## REMARKS

ANNOTATED DRAWING  
Elliptical Crosstraining Exercise Machine  
Inventor: Michell J. Schroder  
Attorney Docket No. 12939-42917

**Fig. 7A**

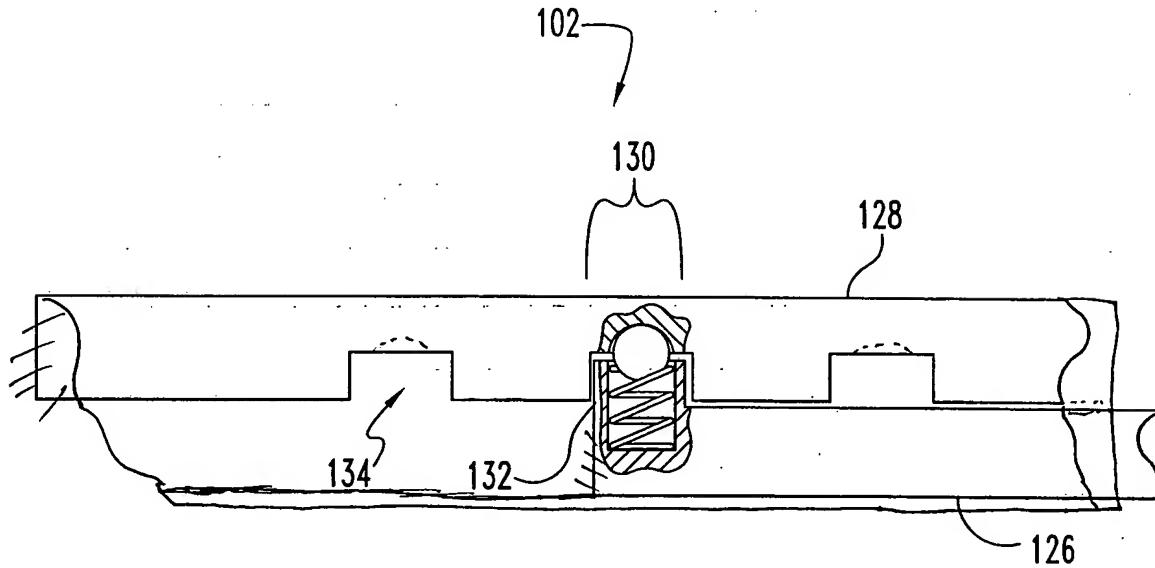
The attached sheet of drawings includes changes to FIG. 5 and FIG. 7A.

The Section 112 grounds of rejection have been addressed and overcome by the present amendments to the drawings and specification. Specifically, the drawings and specification have been amended to more particularly describe the pivotable connection of the footrest support members 102 to the central mechanical portion 104 or gearbox. Drawing FIG 7A and the specification have also been amended to more particularly describe the connection of the two portions 126, 128 of the support member 102. It is submitted that the 35 U.S.C. 112 grounds of rejection have thus been overcome.
